**TOWN OF MOUNTAIN VILLAGE  
REGULAR DESIGN REVIEW BOARD MEETING  
AGENDA**

**THURSDAY FEBRUARY 4, 2021 10:00 AM**

**TO:** Mountain Village Design Review Board  
**FROM:** John Miller, Senior Planner  
**FOR:** Design Review Board Public Hearing; February 4, 2021  
**DATE:** January 22, 2021 (continued from January 7, 2021)  
**RE:** Staff Memo – Initial Architecture and Site Review (IASR) Lot BC513E

① 3 EAST ELEVATION  
1/4" = 1'-0"

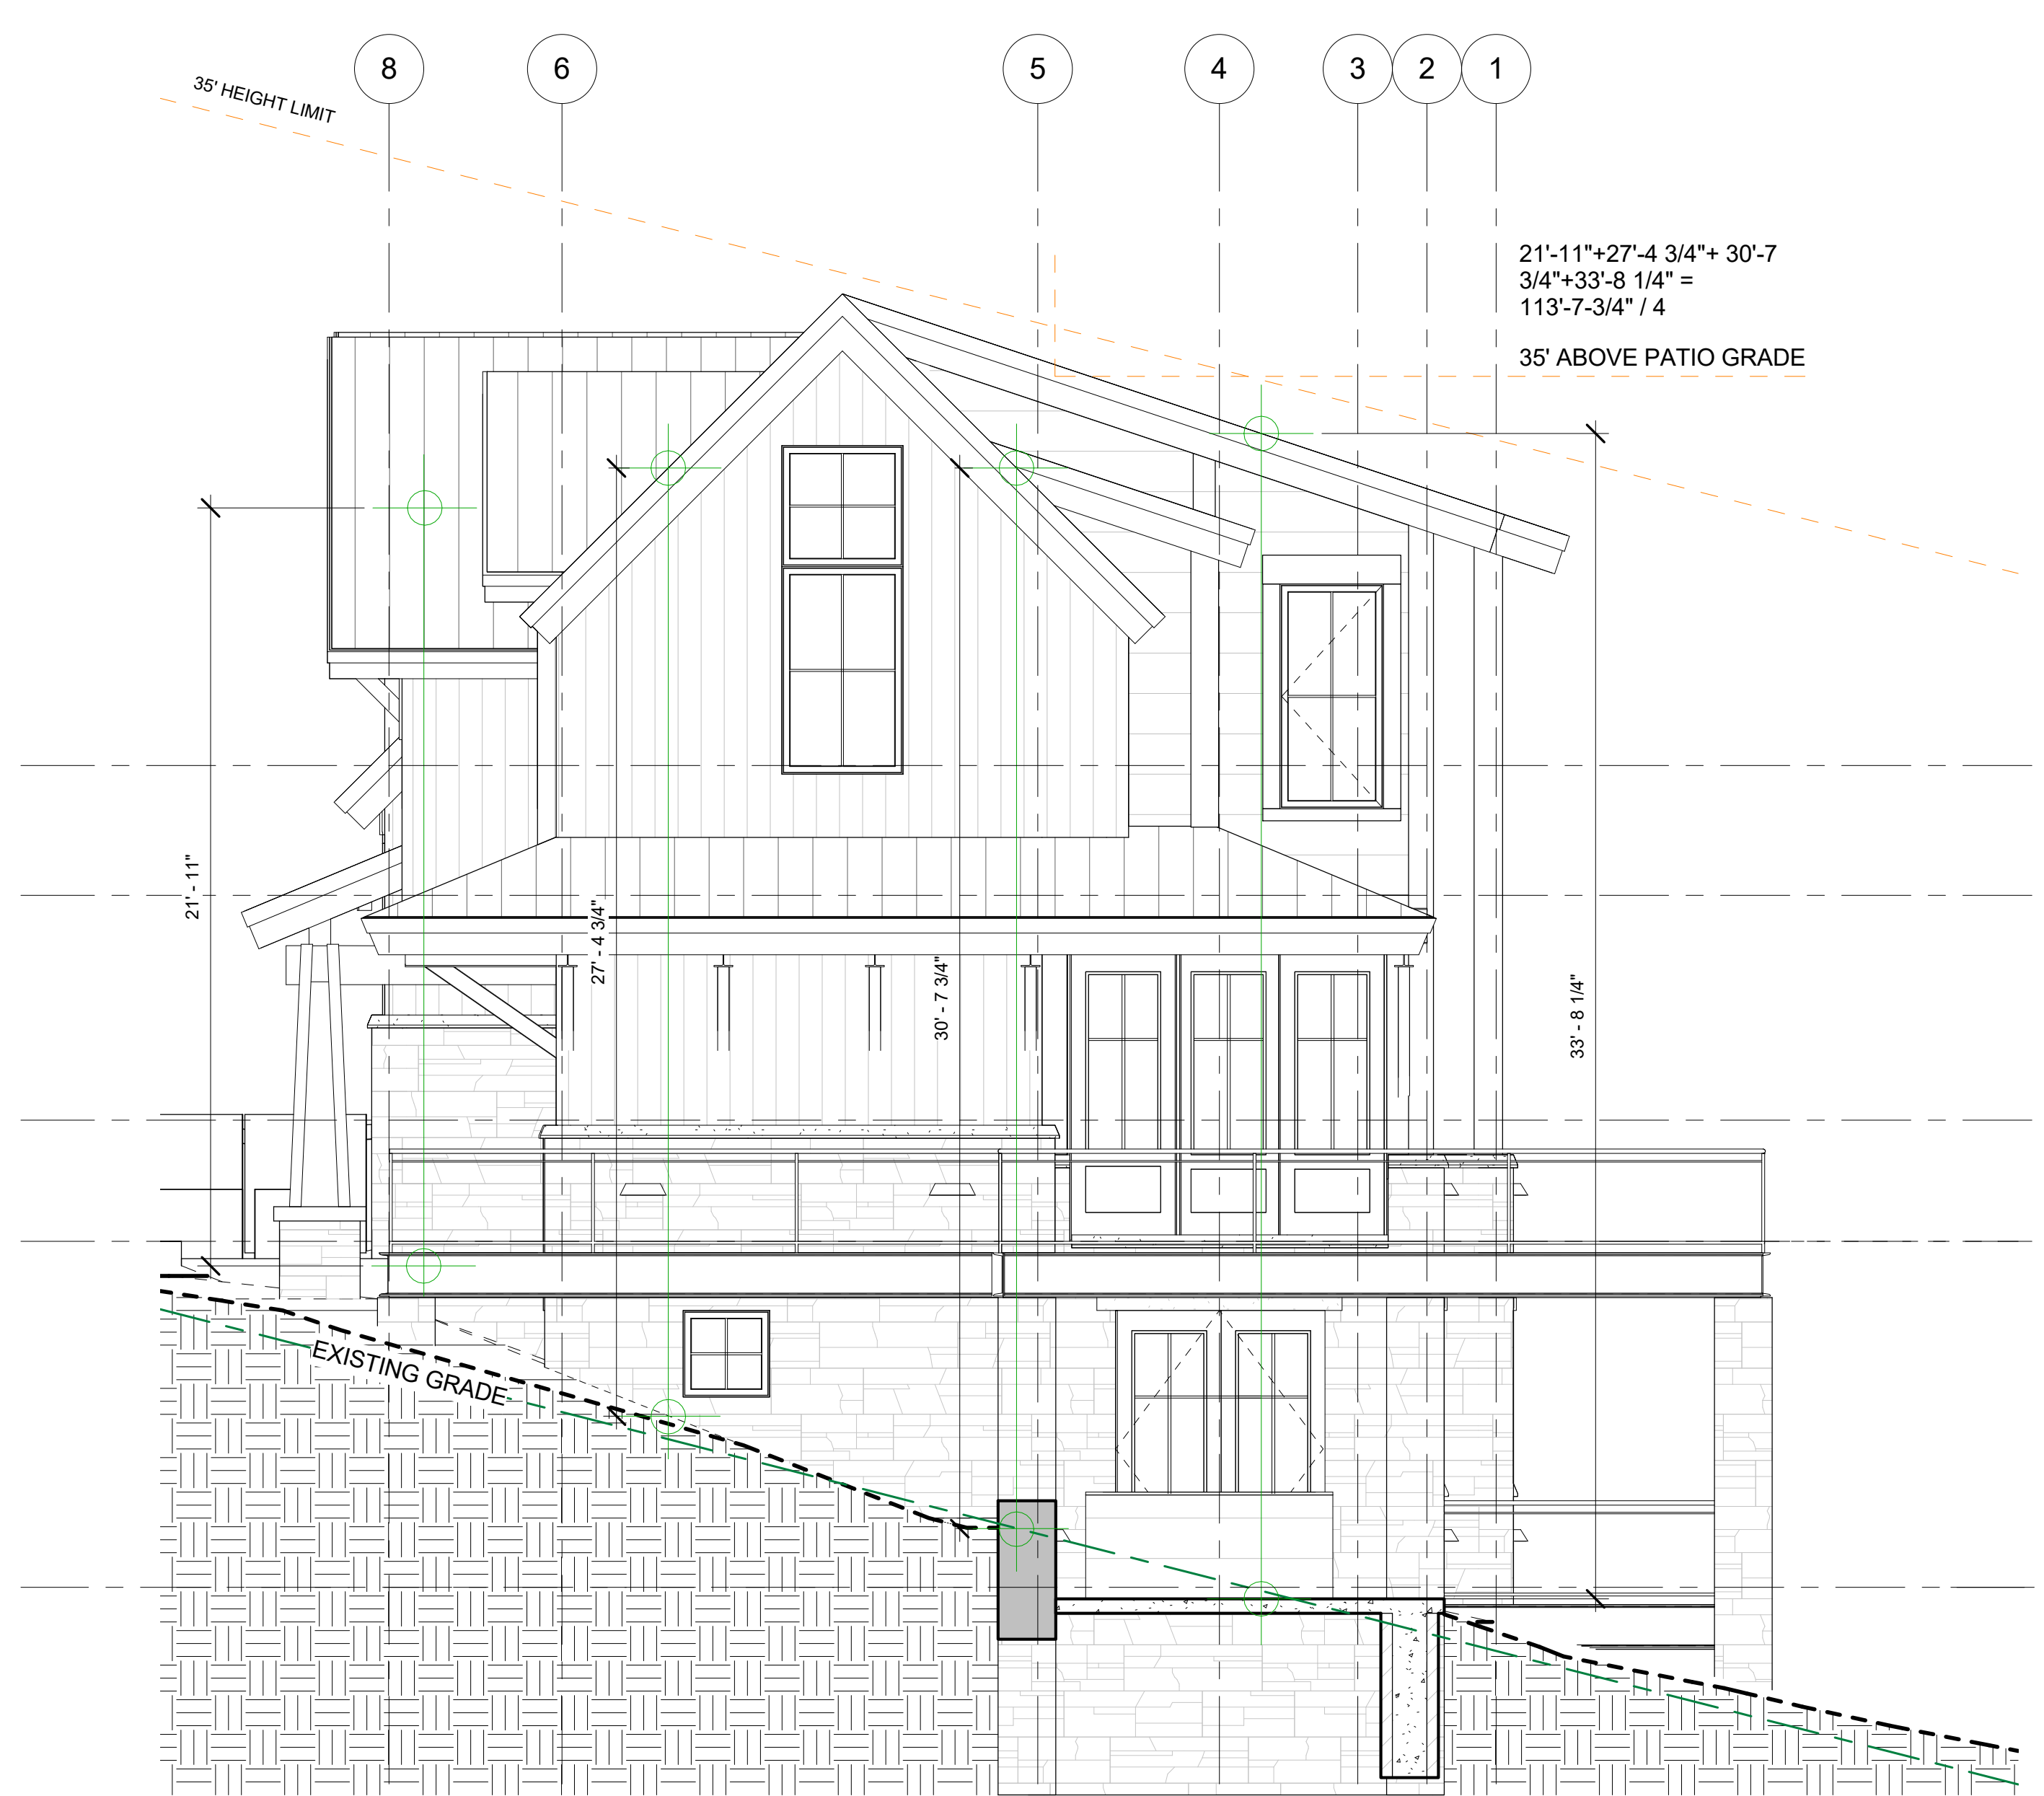
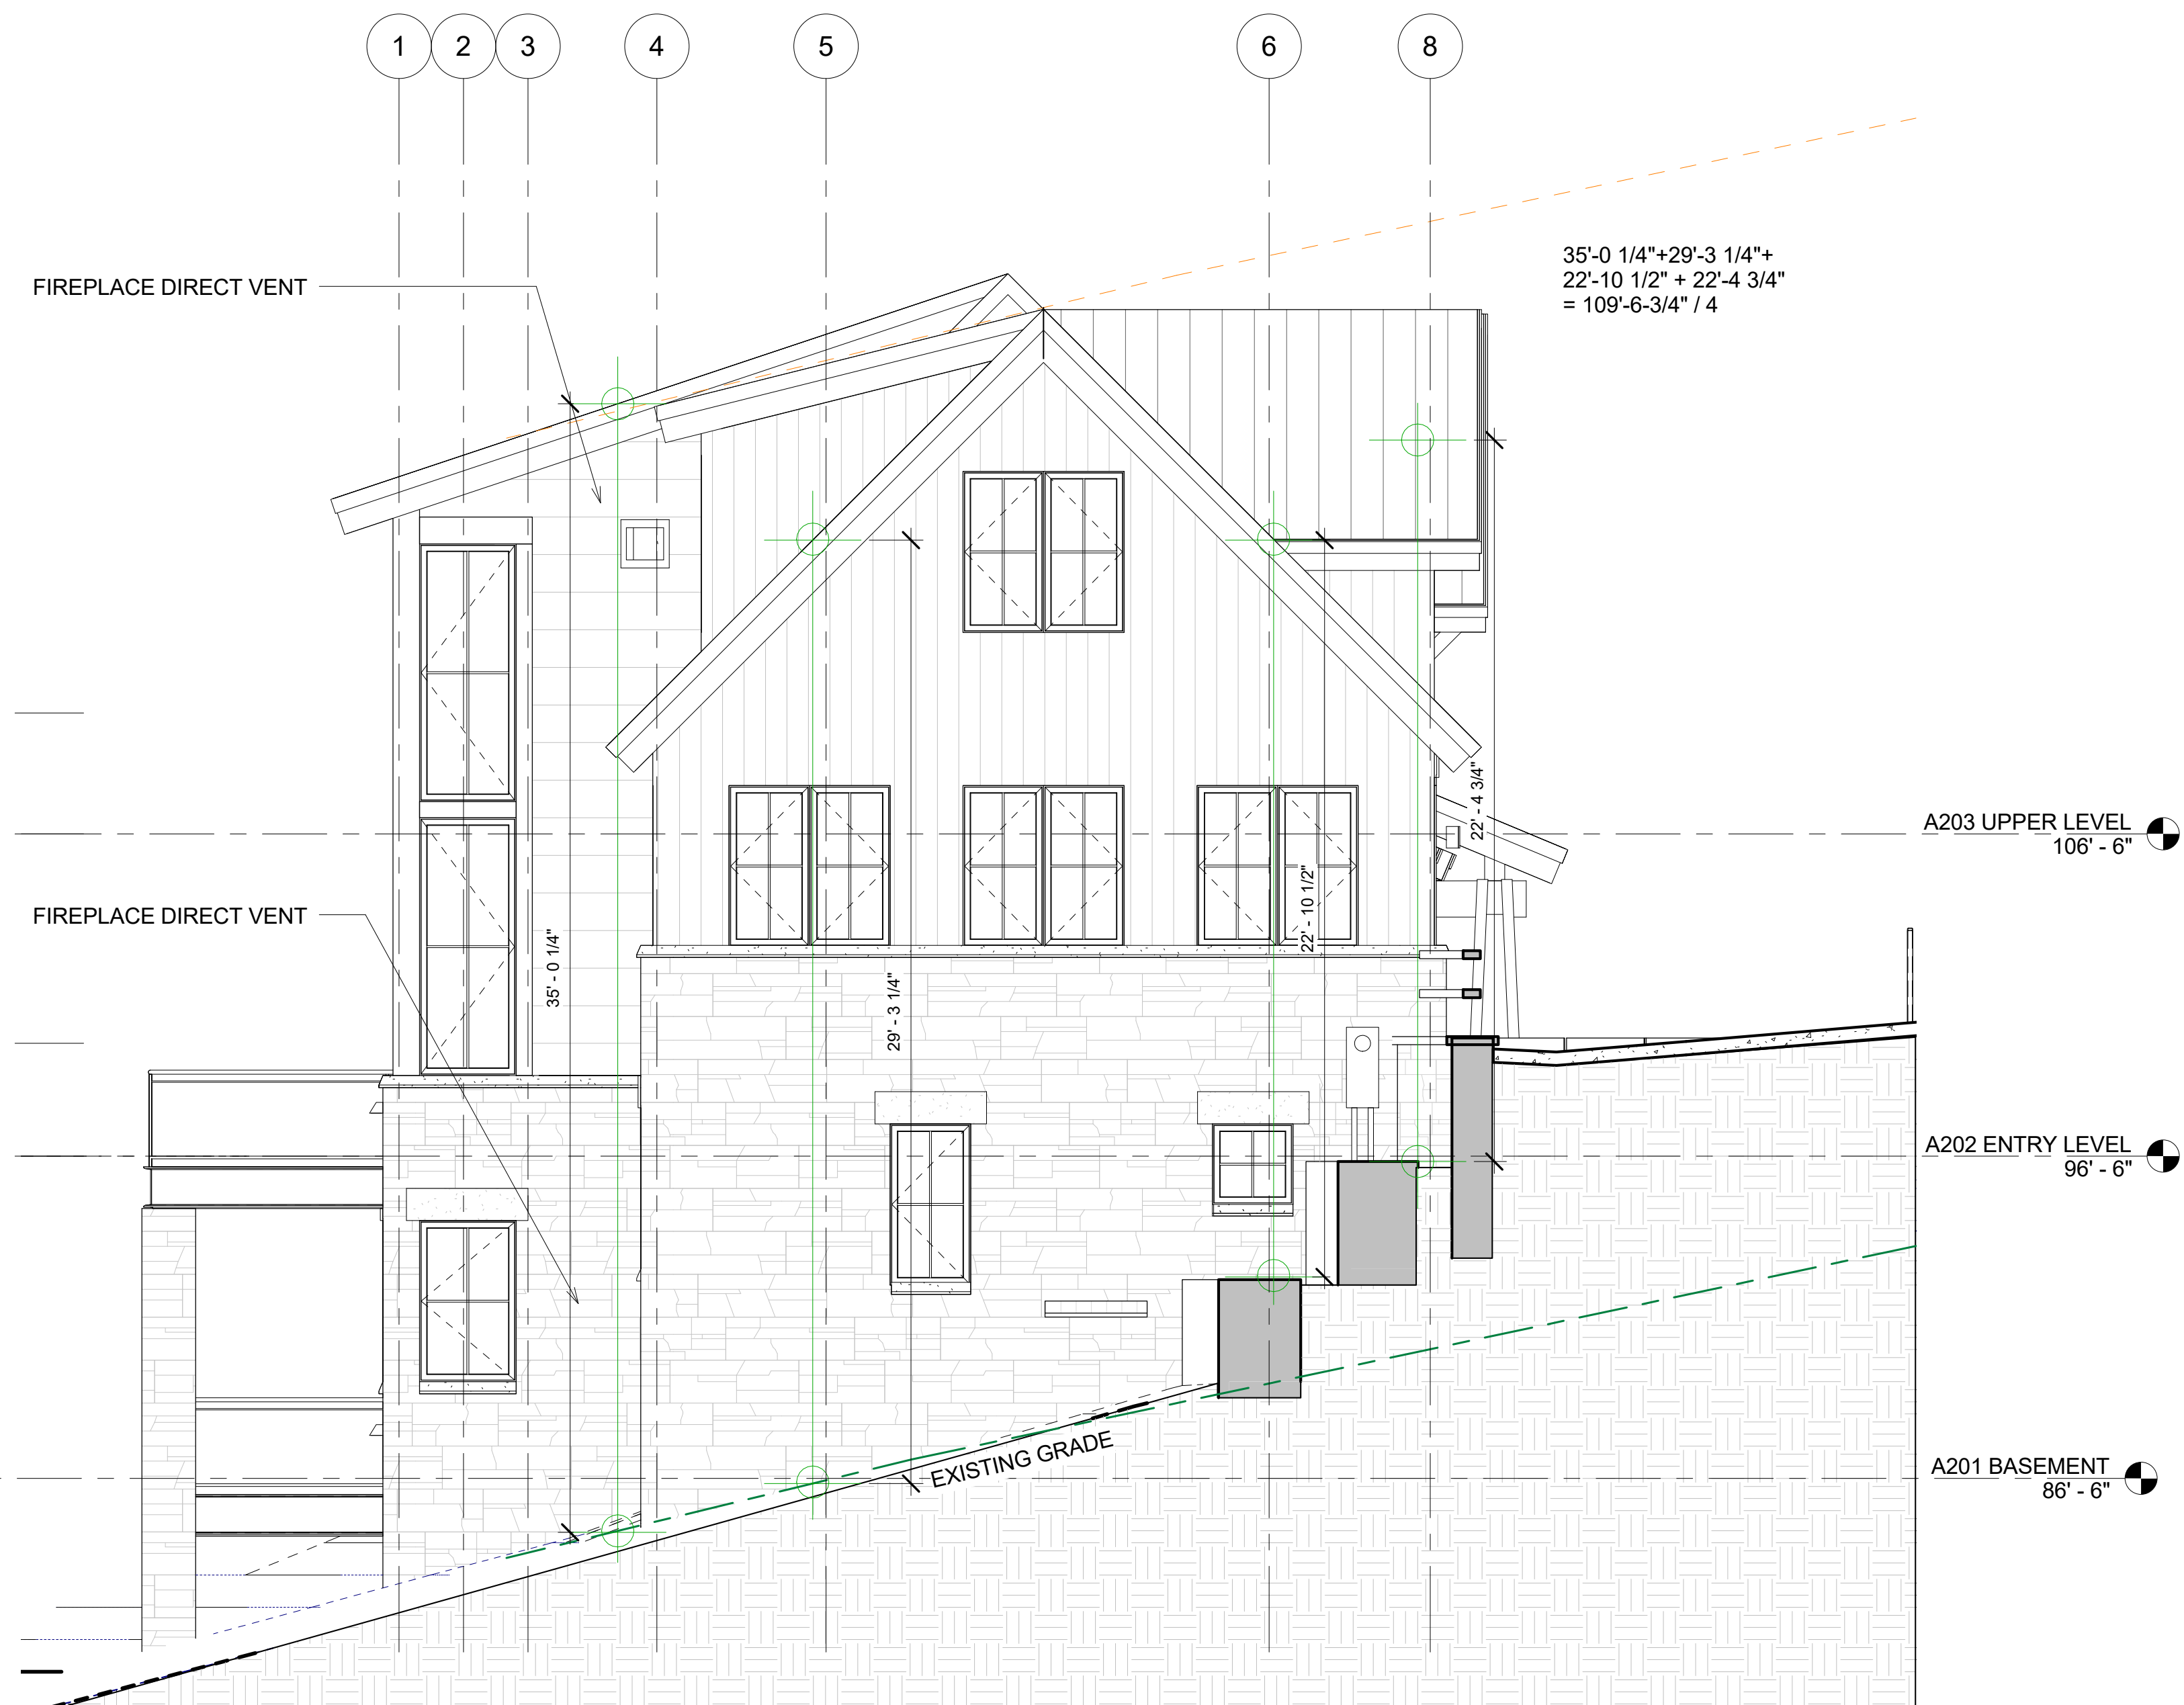
*Staff: As part of this application, the applicant has provided both a Maximum Building Height and Average Building Height calculation on pages A300 – A302 and shown above in Table 1. Since the January hearing, the applicant has revised the plans to demonstrate the most restrictive grade in their parallel slope analysis and it appears that a very small portion of the roof is within the 35-foot plane on the east elevation of the home. It should be noted that this home – given the primary gabled roof forms is allowed a 40-foot maximum building height, and the proposed design is well within that allowance. Staff*

*recommends modifying this height analysis' and particularly the parallel plane in order to demonstrate the heights complying at a 40-foot limit.*
